Aliso Canyon Turbine Replacement Project Construction Non-Compliance Report

Incident Date:	November 1, 2014 through May 19, 2015	Report No.:	NCR-08
Date Submitted:	3/17/2016	Location:	Aliso Canyon Natural Gas Storage Field
Level:	Level 2 Non-Compliance	Relevant Plan/Measure:	MMCRP; NPDES General Permit (SWPPP); APM GE-2
Current Land Use:	Disturbed	Sensitive Resources:	Hydrology, Biology: drainages, riparian, oaks

Figure 1: Recurring BMP Deficiencies by Week (November 2014 – May 2015)

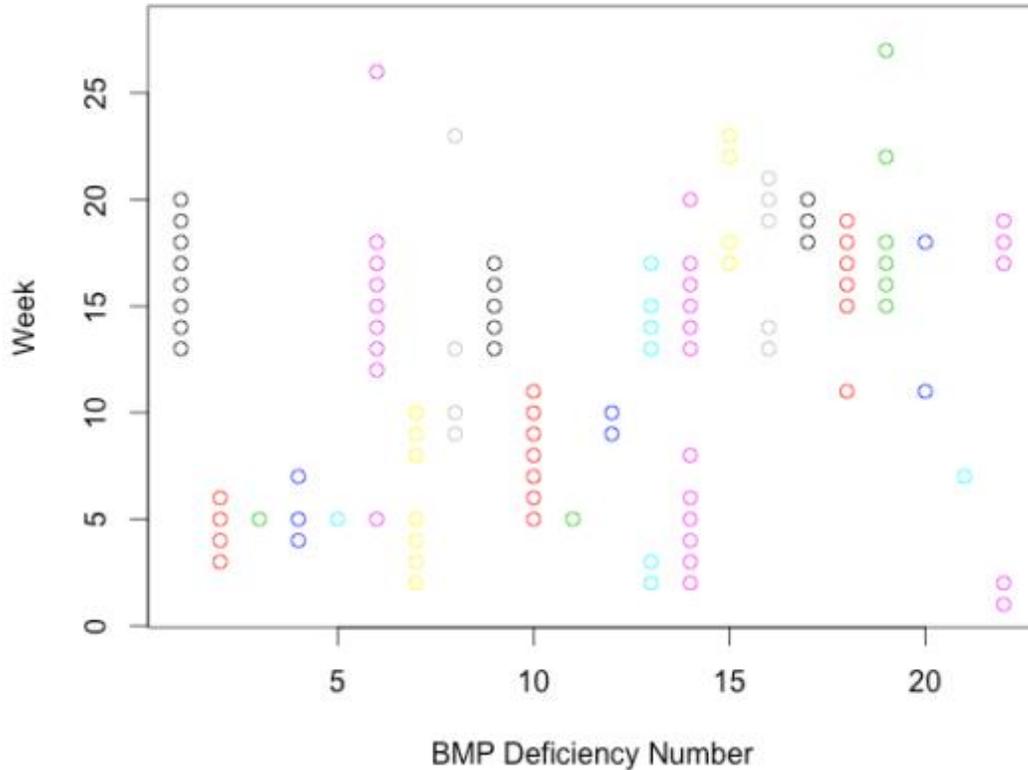
Attachment 1 displays all the BMP deficiency items from November 3, 2014 through May 19, 2015 and the weeks they were documented by the QSP. In some cases many weeks passed between the first report of a deficiency and the last, indicating that BMP improvement or maintenance was not sufficiently resolved within the time frames required by the SWPPP. Some of the longer lasting deficiency items included:

- Covering inactive slopes behind the Central Compressor Station (reported 9 times over a 19 week period);
- Bury toe of silt fence along bottom edge of slope at P-32 Fill Site (reported 13 times over a 21 week period);
- Cover inactive slope and place fiber rolls every 10 feet at the Natural Substation (reported 7 times over a 10 week period); and
- Provide either chemical or mechanical cover for inactive slopes at P-32 Fill Site (reported 4 times over a 7 week period).

The figure in Attachment 1 clearly shows BMP deficiencies were a reported problem that was left unaddressed by SCG for consecutive weeks-to-months. The substantial number (22) of recurring deficiencies and their multi-week duration demonstrate that SCG's SWPPP was not being followed, despite being identified as a high priority by the CPUC/E&E Team (see documentation in NCR-3, NCR-4, and NCR-6). Attachment 2 shows photo documentation of example recurring BMP deficiencies.
